STARTING - PNEUMATIC STARTER - INTRODUCTION OF A SYNCHRONOUS ENGAGEMENT CLUTCH - CATEGORY CODE 7 - MOD.ENG-80-0008

STARTING – PNEUMATIC STARTER – INSTALLATION OF THE SYNCHRONOUS ENGAGEMENT CLUTCH

<u>STARTING -- PNEUMATIC STARTER --</u> <u>INCORPORATE THE PRESSURE FILL FACILITY</u>

Figure 1. Gear Cage and Inserts

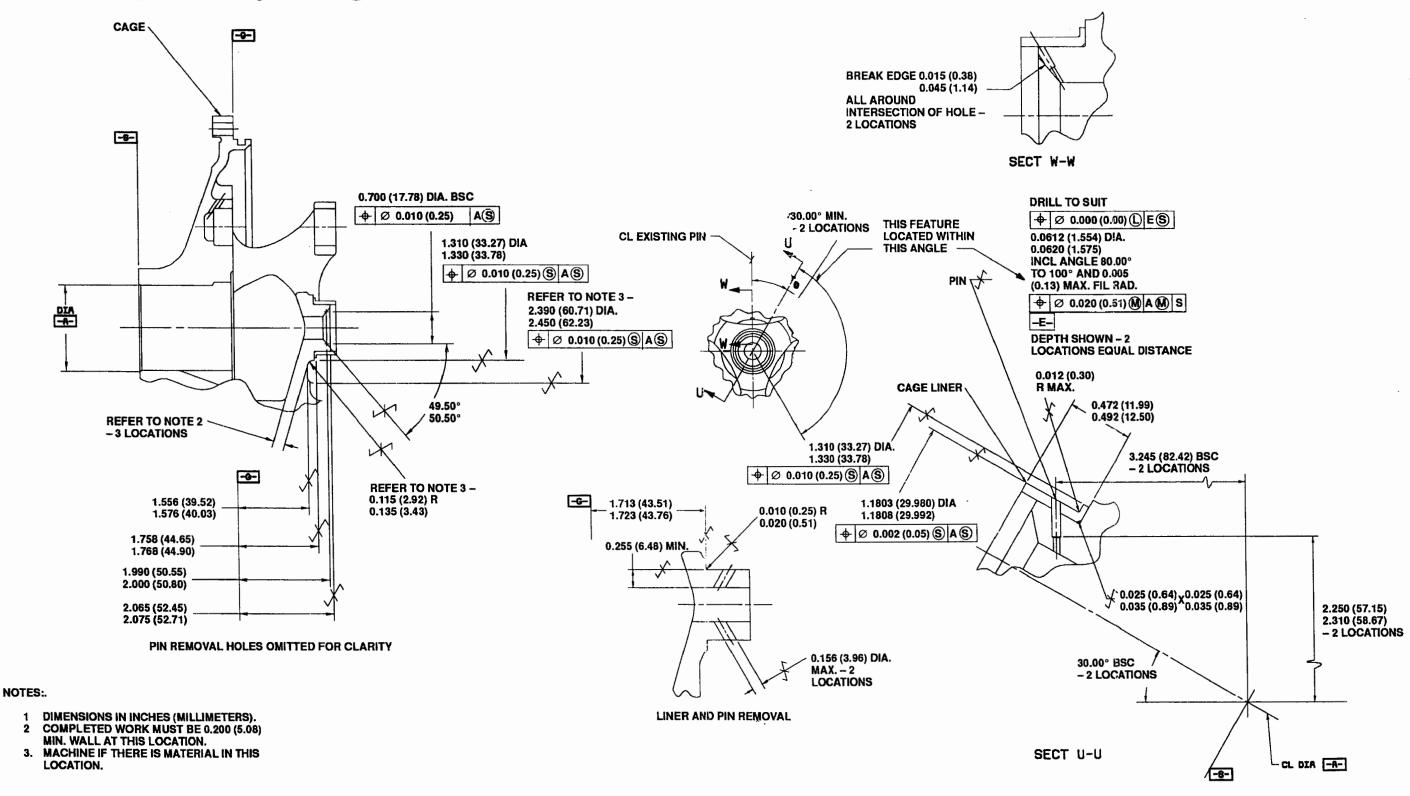
- (4) To change the gear cage and inserts from part number 738138–102 to part number 738138–104, do these steps:
 - NOTE: The rework of the gear cage can make the wall thinner than 0.200 inch (5.08 mm). (Refer to Figure 1, Note 2.) If so, buy a new gear cage, part number 738138–104, to do this service bulletin.

- (a) Remove the cage liner and pins. Refer to Figure 1. You can EDM or machine the pins out of the gear cage.
 - (b) Machine the cage to the dimensions shown in Figure 1.

- (c) Apply protective coating MIL-L-3171 Type VI (chromic acid brush-on treatment) on the surfaces you worked (refer to Figure 1).
 - (d) Machine the inside diameter of the cage liner, part number \$738138–22, for a 0.001 to 0.002 inch (0.0254 to 0.0508 mm) diametral interference fit on the cage liner.

- (g) Apply strontium chromate primer to the tail shaft of the gear cage. Refer to Figure 1.
 - (h) While the strontium chromate primer is wet, install the cage liner. Remove all unwanted strontium chromate primer.

- Let the temperature of the cage and the cage liner go to room temperature.
 - (j) Drill two holes into the cage and the cage liner. Refer to Figure 1.

- (k) Apply strontium chromate primer to two pins, part number 69474A2-5.
 - (I) While the primer is wet, install the pins in the cage liner and the cage. Refer to Figure 1. Remove all unwanted primer.

- (m) Machine the cage liner as shown in Figure 1.

Figure 2. Bearing Sleeve

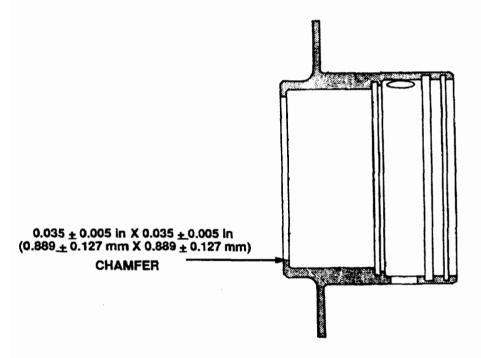
- (a) Machine the bearing sleeve to the dimensions shown in Figure 2.
 - (b) Use the vibration peen method to identify the changed bearing sleeve. The depth of the characters must be less than 0.003 inch (0.08 mm). Do these steps:

Figure 3. Synchronous Engagement Clutch

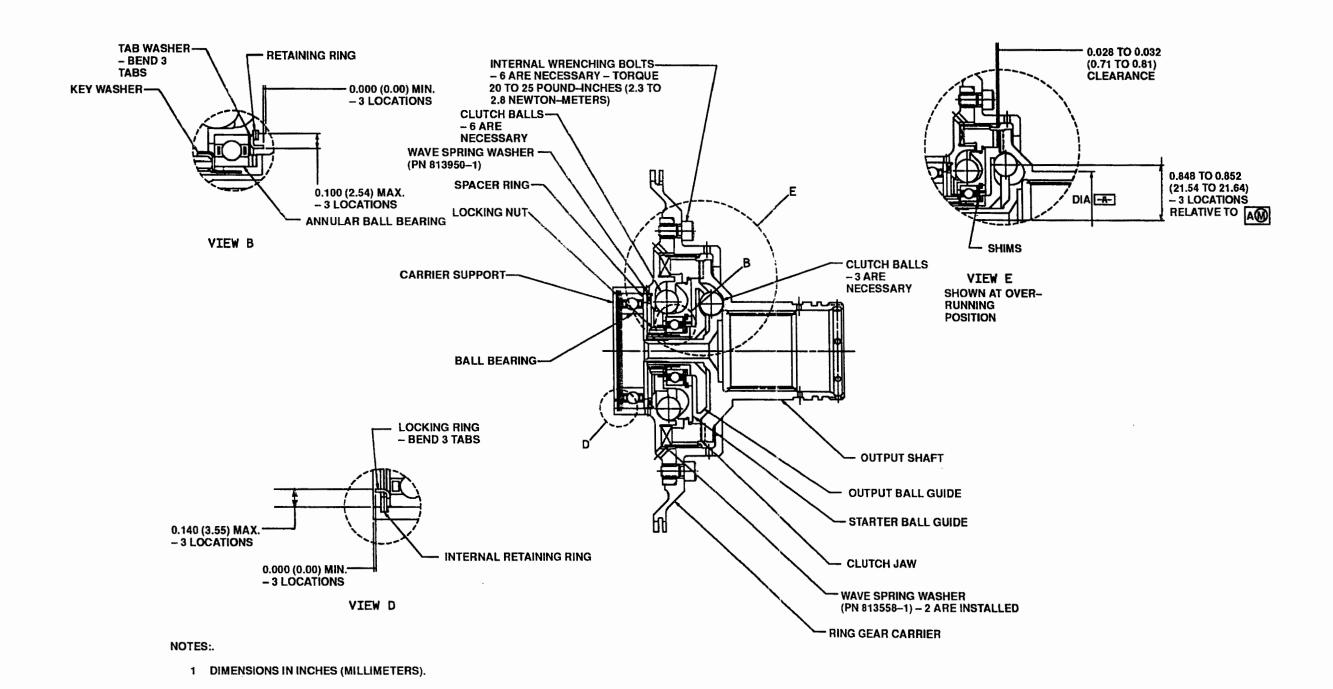
- (a) To assemble the synchronous engagement clutch, part number 803188–1, do these steps (refer to Figure 3 and Figure 4):
 - 1 Install 3 clutch balls, part number 813425–1, into the pockets in the output shaft, part number 813398–1.

- (y) Assemble the clutch with a wave spring, part number 813558–1. Refer to Figure 3 and Figure 4.
- (z) Install the carrier support and the six internal wrenching bolts. Torque the bolts to 20 to 25 in–lbs (2.26 to 2.83 Nm).

Figure 5. Output Shaft Jaw to Clutch Jaw Tooth Clearance

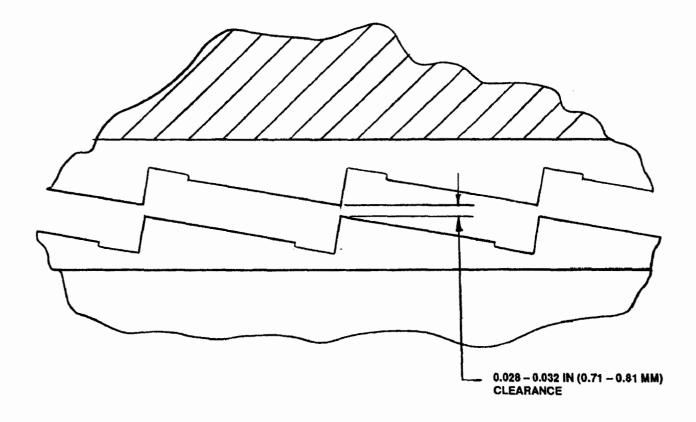
- 13 Remove the locking nut and the key washer.
- 14 Remove the starter ball guide from the output ball guide.
- 15 Add shims, part numbers, 732243-1 thru 732243-7. Make sure the clearance between the tops of the teeth of the output shaft jaw face and the tops of the teeth of the clutch jaw face is 0.028 to 0.032 inch (0.71 to 0.81 mm). Hold the clutch jaw to make sure that no axial movement occurs when the clearance is measured. Refer to Figure 5.

Figure 6. Clearance Between the Ring Gear Carrier and the Output Shaft

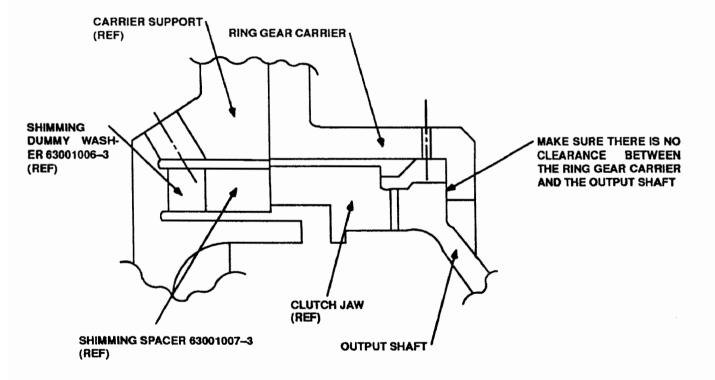
- 21 Install six clutch balls in the pockets of the starter ball guide.
- 22 Install the shimming dummy washer, part number 63001006–3, into the carrier support, part number 813389–1. Refer to Figure 6.

- <u>25</u> Make sure there is no clearance between the ring gear carrier and the output shaft. Refer to Figure 6.
- <u>26</u> Install these parts into the carrier support (refer to Figure 7):

- 8 Make sure there is no clearance between the ring gear carrier and the output shaft. Refer to Figure 6.
- Remove these parts from the carrier support (refer to Figure 3 and Figure 4):

Figure 7. Carrier Support Shimming Tools

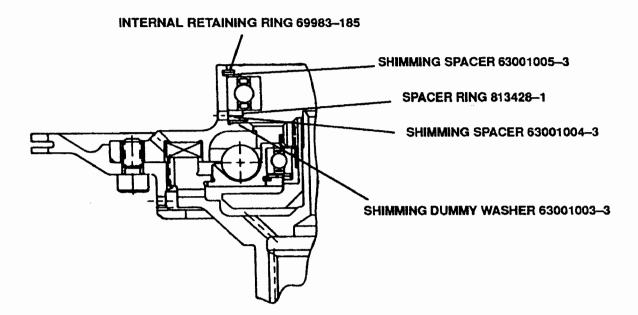
- 10 Install these parts into the carrier support (refer to Figure 7):
 - Shimming dummy washer, part number 63001003–3
 - Shimming spacer, part number 63001004–3

Figure 8. Assembly of the Ring Gear and the Carrier

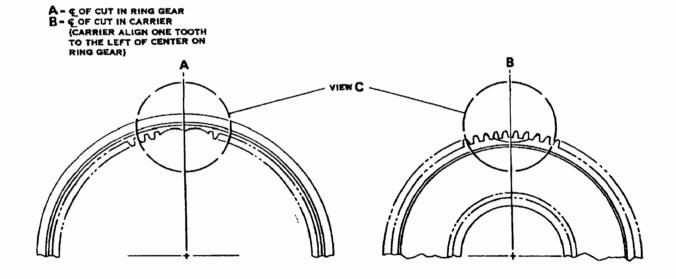
- (9) To assemble the starter with the synchronous engagement clutch, part number 803188–1, do these steps (Refer to Figure 8):
 - (a) Put the synchronous engagement clutch and the ring gear, part number 750501–1, on a flat surface. The cutaway sections in the upper rows of each of the splines must be as shown in Figure 8.

- (b) Install the retaining ring, part number 728890–1, between the double rows of splines on the ring gear carrier. The bent ends of the retaining ring must point down. The right end of the retaining ring must be adjacent to the first tooth to the right of the cutaway in the ring gear carrier splines. Refer to 8.

- (d) Install the ring gear carrier. Align the centerline of the cutaway with the center in the cutaway section of the ring gear. Refer to Figure 8.
 - (e) Push the free end (the left end) of the retaining ring to the left to lock the ring gear and the ring gear carrier together.

Figure 9. Clutch with Shims and Oil Slinger

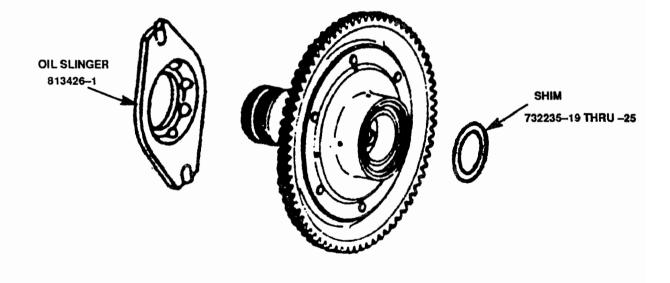
Install the oil slinger, part number 813426-1, on the output shaft. (i) Refer to Figure 9.

Figure 10. Shimming Fixture

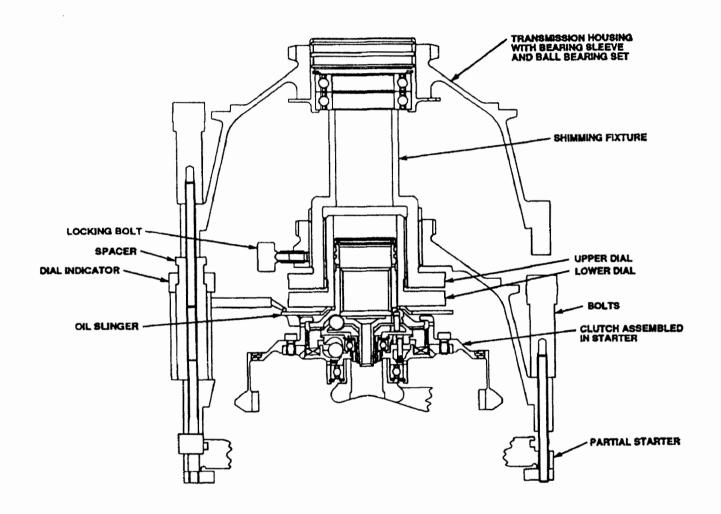
- Bolt the shimming fixture to the Pneumatic Starter with the three bolts supplied with the shimming fixture. Make sure that the bolts are an equal distance apart. Refer to Figure 10.

- (k) Hold the dial indicator in the dovetail clamp attached to the shimming fixture. The dial indicator stem must touch the oil slinger. Refer to Figure 10.

- Make sure that the tube at the top of the fixture does not touch the bottom bearing in the bearing sleeve. If necessary, turn the top dial of the fixture clockwise to move the tube away from the bearing. Refer to Figure 10.

Figure 1. Pressure Fill Adapter Plugs

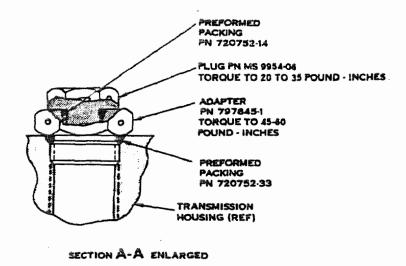
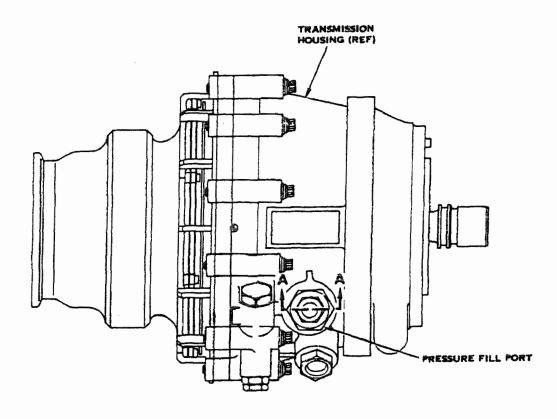
- A. To change Pneumatic Starter part number 790425A4 to part number 790425A3, do these steps (refer to Figure 1):
 - (1) Remove and discard sight plug, part number 738277–3.
 - (2) Install new packing, part number 720752–33, onto adapter, part number 797845–1.

- (3) Install adapter into transmission housing pressure fill port. Refer to Figure 1.
- (4) Torque the adapter to 45 to 60 pound-inches (5.09 to 6.78 Nm).
- (5) Use lockwire MS20995C20 to lockwire the adapter to the transmission housing. Refer to AS567.
- (6) Install new packing, part number 720752–14, onto the plug, part number MS9954–06.
- (7) Install the plug into the adapter, part number 797845–1. Refer to Figure 1.
- (8) Torque the plug to 20 to 35 pound—inches (2.26 to 3.96 Nm).
- (9) Use lockwire MS20995C20 to lockwire the plug to the transmission housing. Refer to AS567.
- (10) Remove and discard the oil fill instruction plate, part number 732229–1.
- (11) Install a new oil fill instruction plate, part number 792997–1, as given in the <u>ASSEMBLY</u> procedures of the CMM.
